Preah Vihear (Cambodia)

No 1224

Official name as proposed by the State Party: The Sacred Site of the Temple of Preah Vihear

Location: Kantuot Commune, Choam Ksan District, Kingdom of Cambodia

CARTE ADMINISTRATIVE POUR LA GESTION PRÉPARÉE PAR LE ROYAUME DU CAMBODGE
EN VUE DE L'INSCRIPTION DANS LA LISTE DU PATRIMOINE MONDIAL

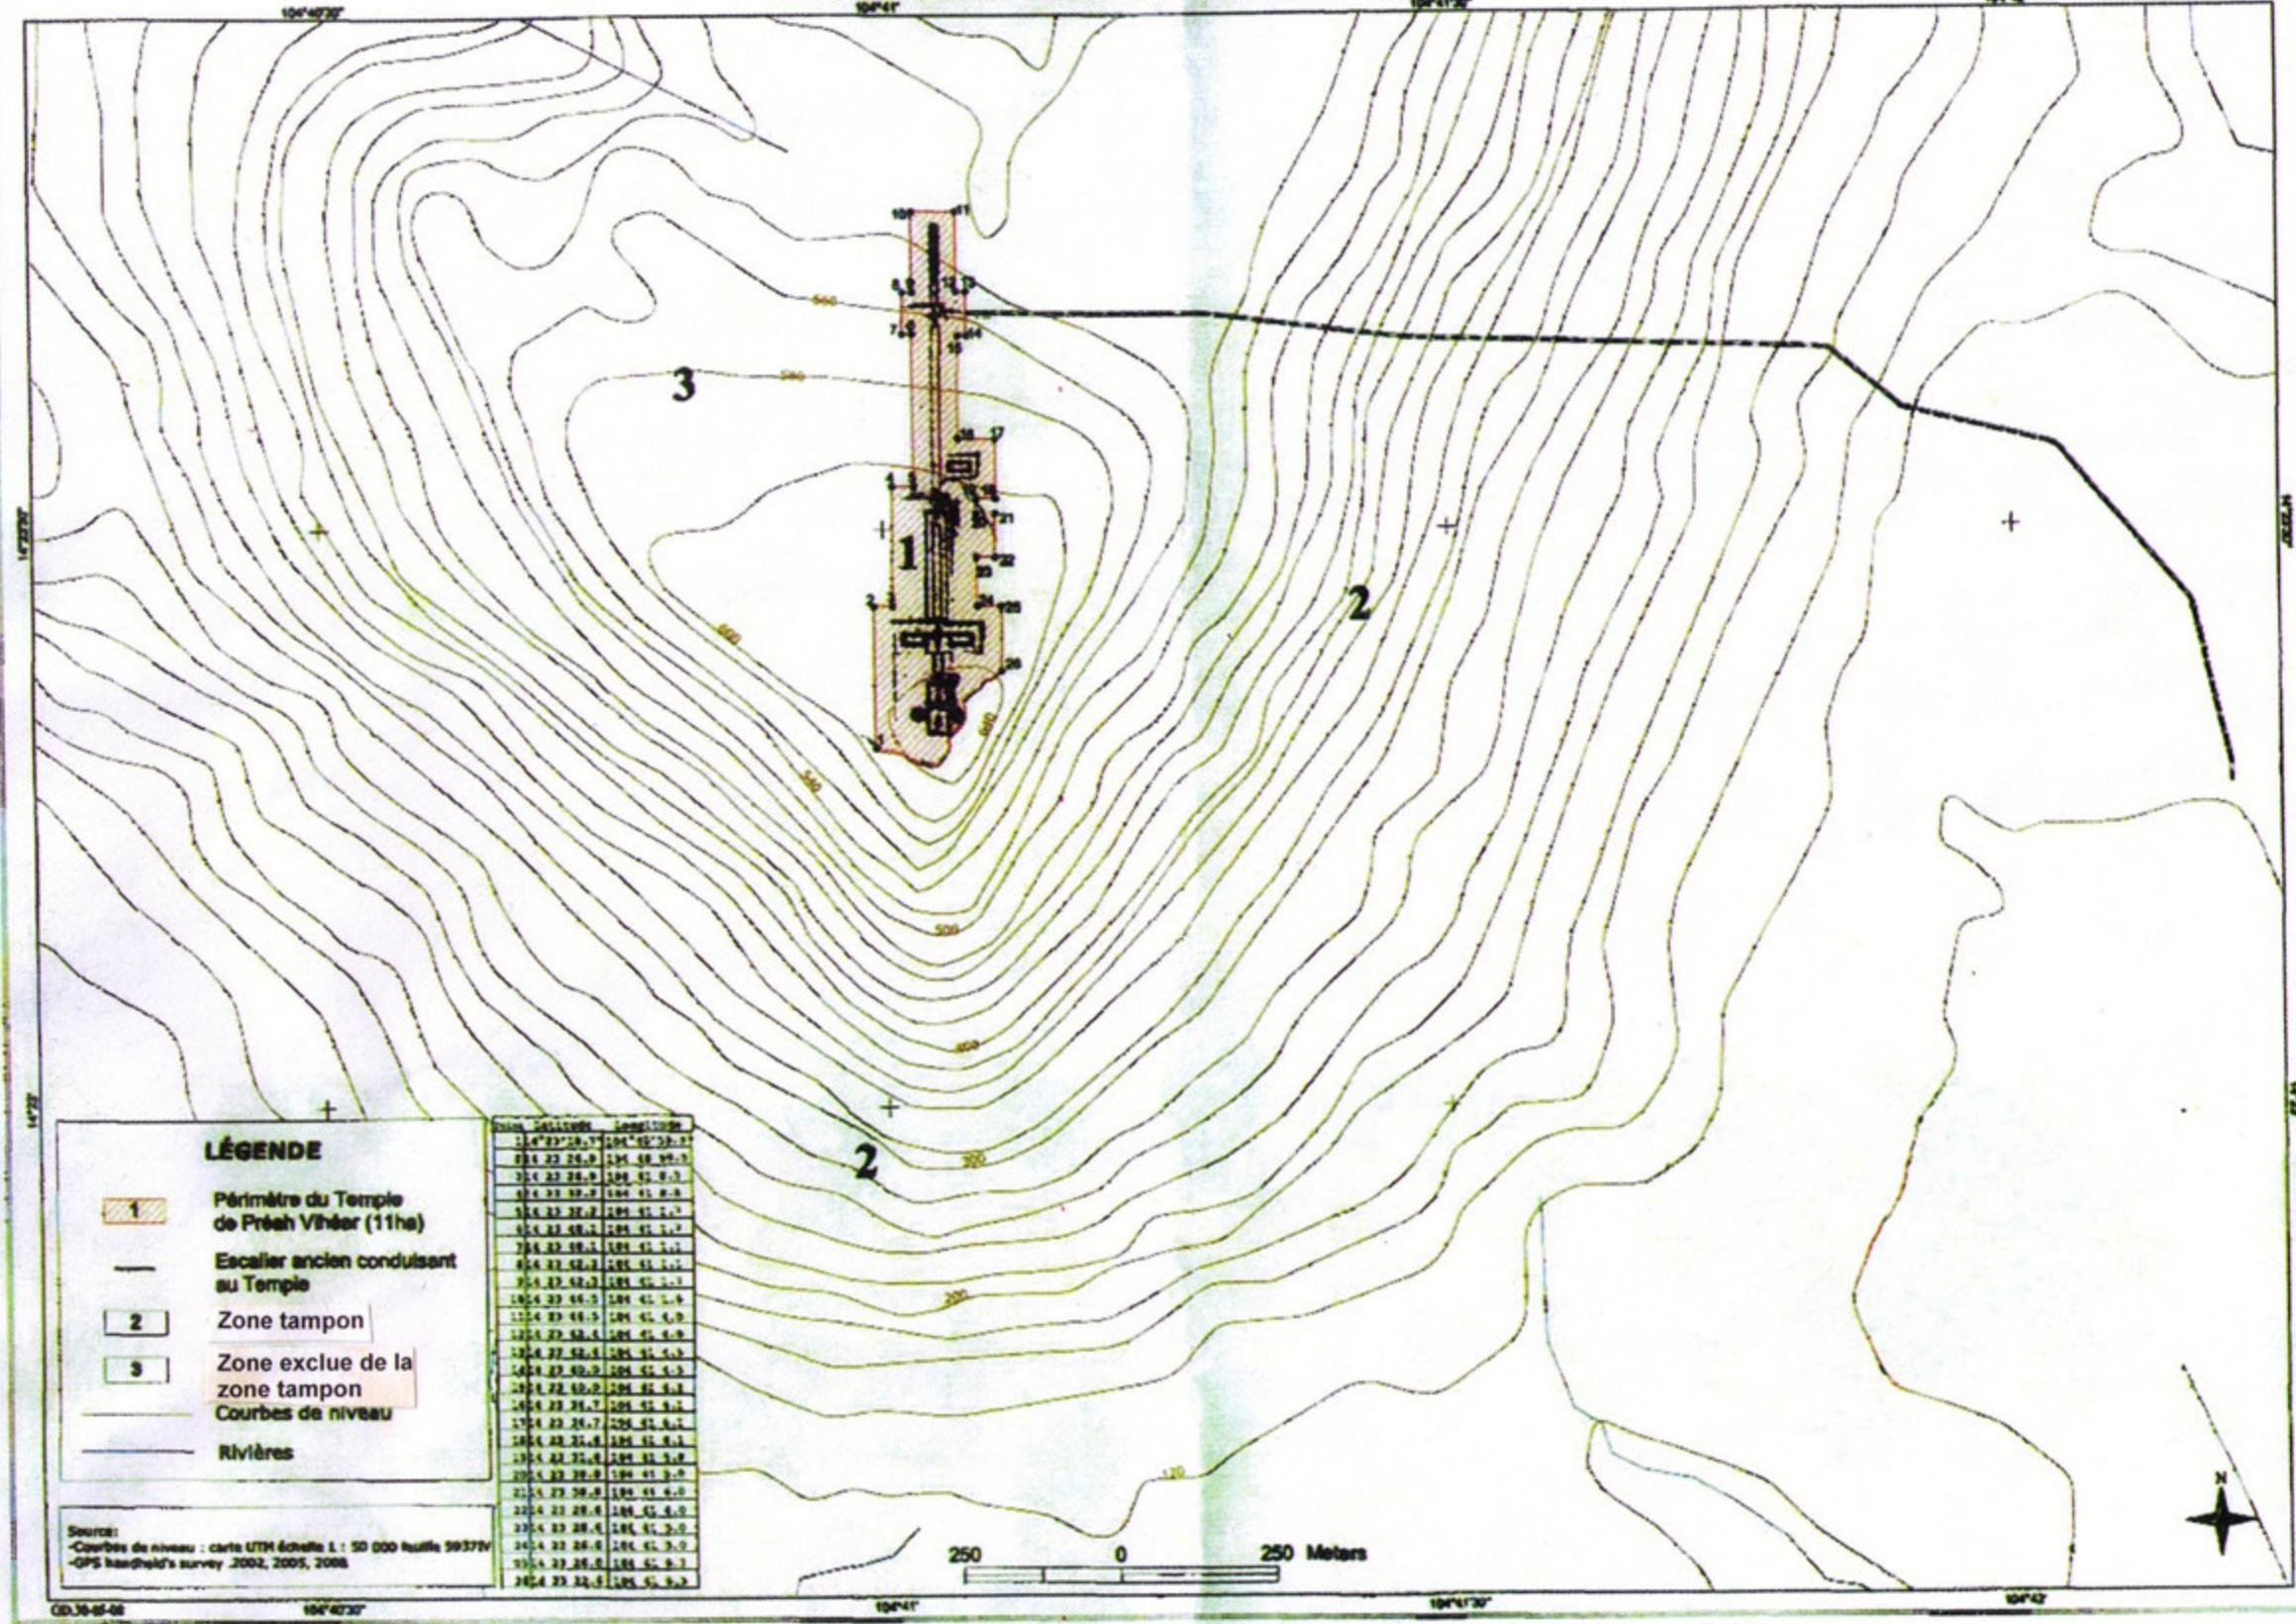
ICOMOS notes that although a map has been provided for the revised core area, this is at a small scale and needs to be augmented with a more detailed map. No detailed maps have been provided for the boundaries of the buffer zone and areas to the north and west, which will be subject to joint management arrangements between Cambodia and Thailand, (only general areas have been suggested).

ICOMOS wishes to acknowledge, and bring to the attention of the Committee, that the map submitted, with its undelineated buffer and joint management zones, is a

source of concern in terms of the long-term conservation and protection of the property;

- Detailed map of the core area and a map delineating the buffer zone;
- Updated Nomination dossier to reflect the changes made to the boundaries;
- Confirmation that the management zone for the property will include the core zone, buffer zone and joint north and west zone;
- Progress report on the preparation of the Management Plan, including the joint management plan to be prepared with the Thai authorities for the areas to the north and west of the core zone;
- A delineation of the areas to the north and west that will be covered by the joint management plan;
